PROJECT: EWING IRRIGATION FACILITY UPGRADES
AND PARCEL MAP

CITY OF LAS VEGAS			DATE:
INTER-OFFICE MEMORANDUM			August 25, 2011
TO: Land Development Services Department of Public Works			FROM: Albert Sung, P.E. Flood Control Project Engineer Department of Public Works
SUBJECT: Drainage Study for: Ewing Irrigation Facility Upgrades and Parcel Map			COPIES TO: RCI Engineering
Cross Streets:	West of Rancho Drive & Michael Way		Ewing Irrigation
File Number:	F:\Depot\DSMemos\DS4536A.ZNA.doc		Bart Anderson, P.E., DevCo
Parcel Number:	138-12-301-013		CCRFC
Zoning Action:	PMP-XXXXX		NDOT
FEMA Flood Zone	YES X	NO	
Proposed Storm Drain	YES	NO X

**TECHNICAL DRAINAGE STUDY
FOR
EWING IRRIGATION FACILITY UPGRADES
AND PARCEL MAP**

DESCRIPTION: GRADING PLAN

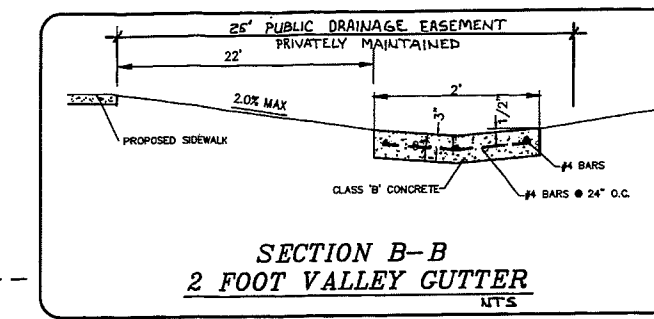
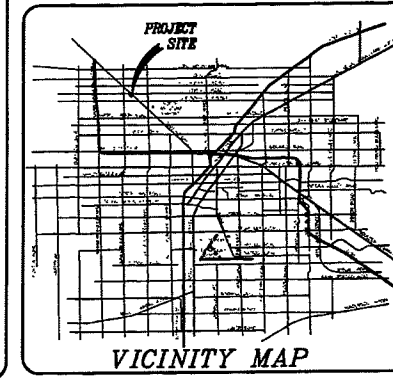
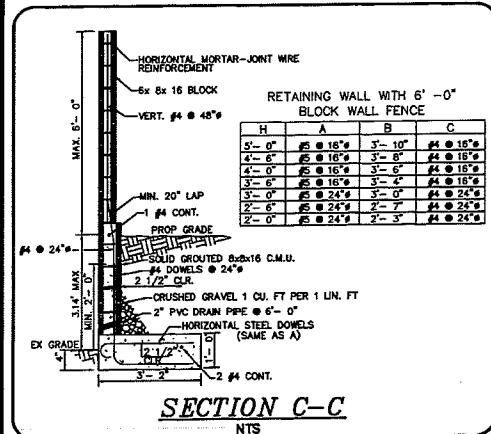
4. Provide at least two HEC-RAS stations with base flood elevations (BFEs) labeled on the grading plan per the **Rancho / US95 LOMR Study**. The two stations appear to be STA. 171+73.04 and STA. 165 + 42.69.
5. Label an existing 25.33'-concrete channel drainage easement with recorded document number on the grading plan.
6. Clearly label the proposed lot line on the grading plan.
7. Label the finish floor elevations of existing houses along the west boundary of the subject property.
